PCN (Product Change Notice)

PCN Number: PCN_NcAENA_20261114 Affected Series: WE-AENA Affected Part Number: see table below PCN Date: 2026-08-14 (YYYY-MM-DD) Effective Date: 2026-11-14 (YYYY-MM-DD)	Change Category: ☐ Equipment/Location ☐ General Data ☐ Material ☐ Process ☒ Product Design ☐ Shipping/Packaging ☐ Supplier ☐ Software
Contact: Product Management Phone: +49 (0) 7942 - 945 5001 Fax: +49 (0) 7942 - 945 5179 E-Mail: pcn.eisos@we-online.com	Datasheet Change: ☒ Yes ☐ No Attachment: ☐ Yes ☒ No

Before change	After change

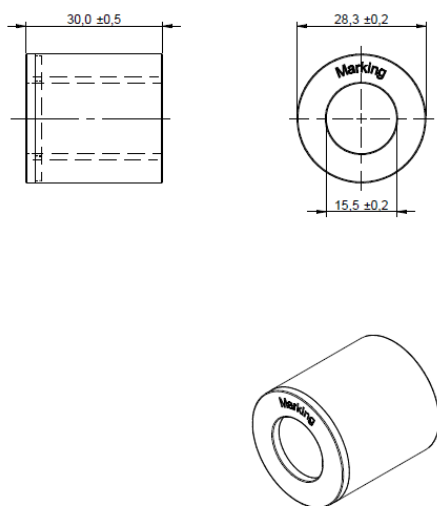
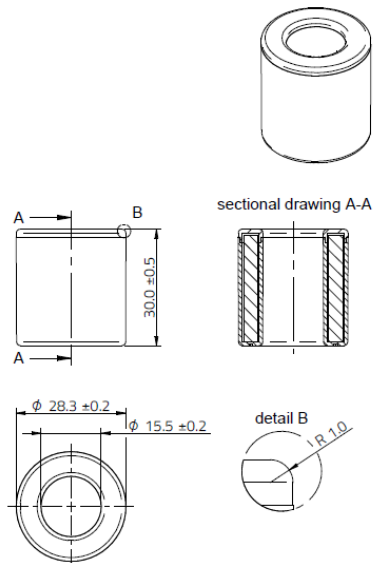
To improve product assembly, Würth Elektronik eiSos will increase the corner radius of the core casing from 0.2 mm to 1.0 mm.

The drawings have been updated for all affected part numbers to include corner detail views and sectional drawings. No dimensional changes have been made.
